25 March 2024

Re: DA2023/1658 Alterations and additions to a dwelling house including the replacement and extension of an Inclined Passenger Lift at 948 Barrenjoey Road Palm Beach

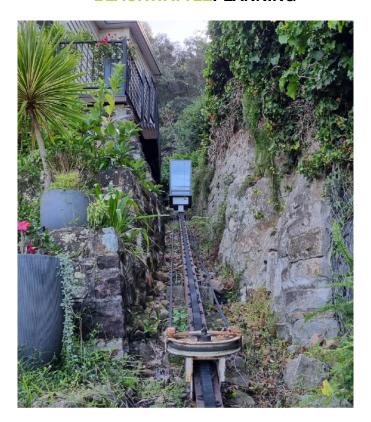
Your measurement of 1.2m above ground appears to have been taken from **an excavated level** at the base of the significant existing cut which accommodates the current inclinator. Natural ground lines are much higher either side of the inclinator rail for a large proportion of its length, as is demonstrated in the section drawing. This is also plainly evident on site.

The below photo (Source: Peter Downes Designs) shows the extent of retained natural ground either side of the existing inclinator rail, which will also be the location of the proposed replacement rail.

We encourage you to revisit the original plans and review the additional sectional drawings now provided, which demonstrate that the new inclinator is not 10m longer than existing as you state, that the new inclinator will be accommodated in the existing deeply excavated corridor, and that the section of inclinator rail that is proposed to extend to Landing No. 3 is at most 745mm above ground and not 1.2m as you suggest.
